Natural Resources Wales Permitting decisions

Refusal

We have decided to refuse the permit for Parry's Quarry

The Applicant is RJS Engineering Limited

Figure 1. Measured H₂S trace gas concentrations averaged on various landfill sites.

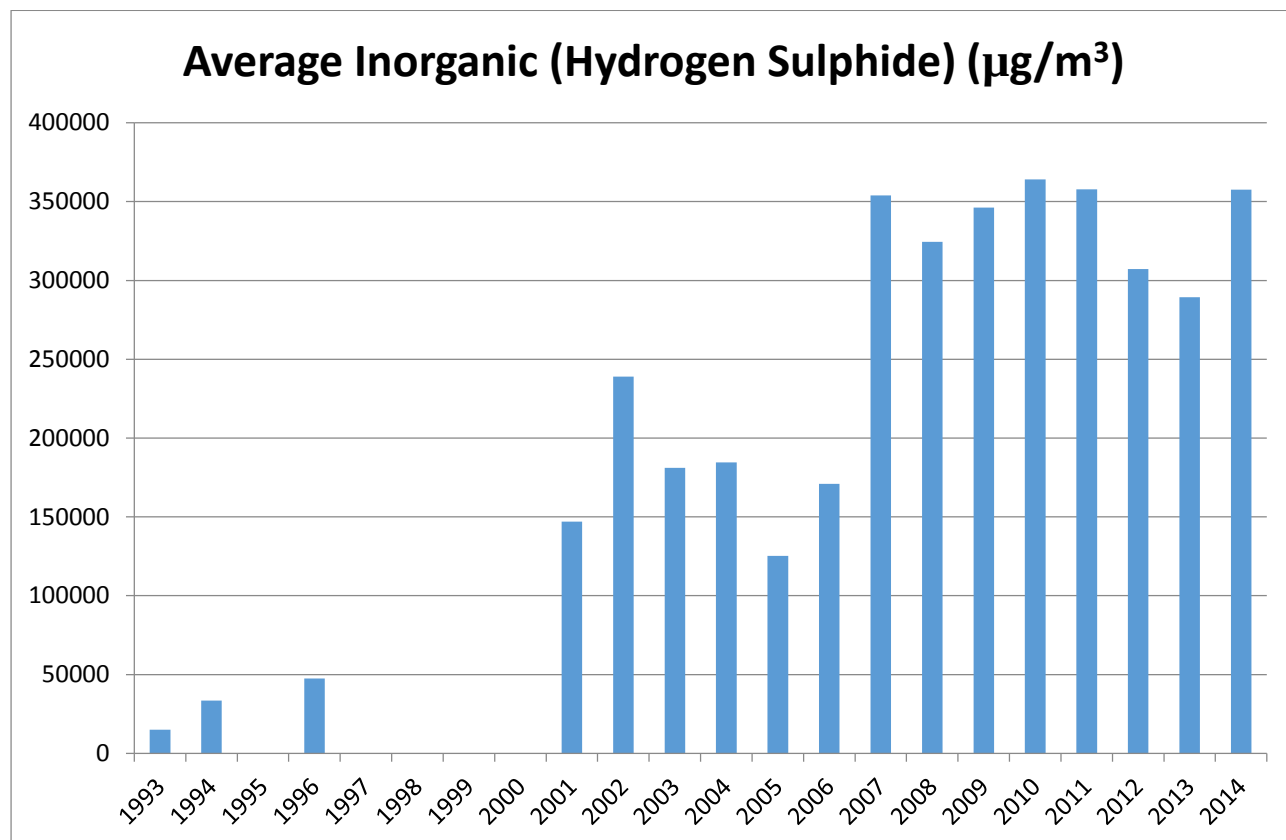
Figure 1 shows average H₂S trace gas concentration measurements up to 2014. H₂S concentrations in Figure 1 can be divided into three groups: (i) the concentration data was not complete from 1993 to 2000; (ii) relatively stable but lower concentrations between 2001 and 2006; (iii) relatively stable but higher concentrations from 2007 to 2014.

H₂S trace concentration measurements in group (iii) from 2007 to 2014 are more relevant than the GASSIM default values. The 2007 concentration in Figure 1 was

Figure 2. GASSIM default H₂S trace gas distribution (in red) compared with fitted measurements from 2007 to 2014 (in green). There are total 1012 measures from 2007 to 2014.

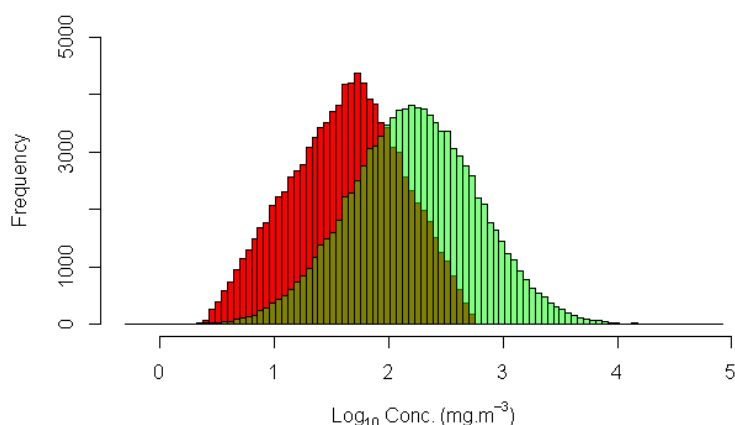
Figure 2 shows GASSIM default H₂S trace gas concentration distribution (in red) compared with fitted measurements from 2007 to 2014 (in green). There are in total 1012 measures from 2007 to 2014.

GASSIM default H₂S trace gas concentration distribution was LogTriangular distribution, whereas for the 2007 – 2014 measurements the distribution is best fitted as LogNormal distribution. It is apparent that the GASSIM default distribution has a lower mean concentration than the distribution based on 2007 – 2014 measurements.

Figure 3. Comparison of predicted H₂S trace gas emission rate between GASSIM default distribution and 2007-2014 measurement distribution.

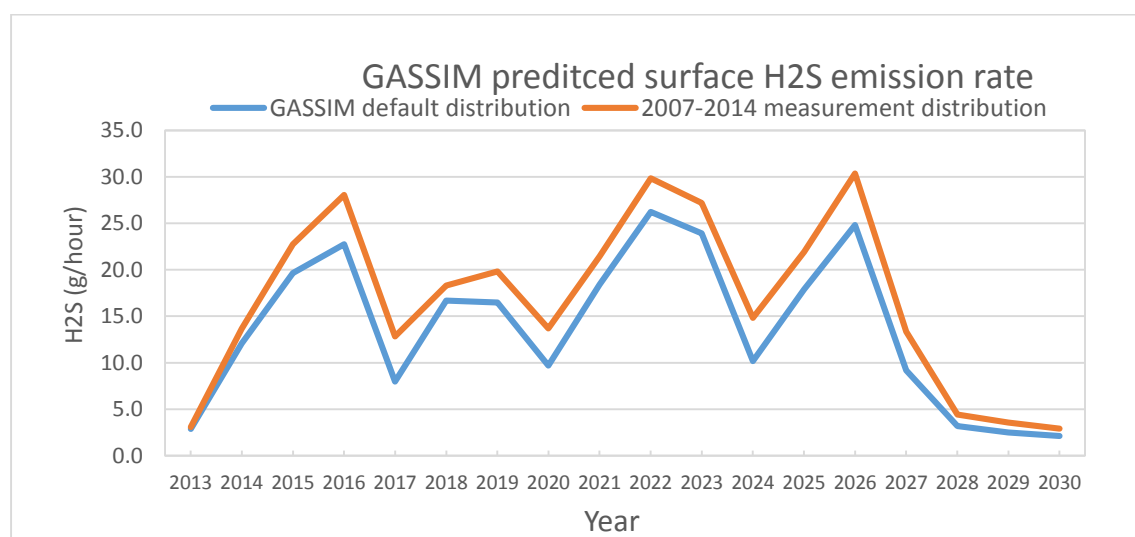
Figure 3 shows the comparison of predicted H₂S trace gas emission rates between GASSIM default distribution and 2007-2014 measurement distribution. As expected, the GASSIM default distribution consistently gave lower H₂S emission rate than the 2007-2014 measurement distribution. The predicted H₂S emission rate at 2026 was modelled by AMEC using GASSIM default values, if the measured 2007-2014 distribution values had been used then the predicted emission rates would be approximately 20% greater than the applicant modelled.
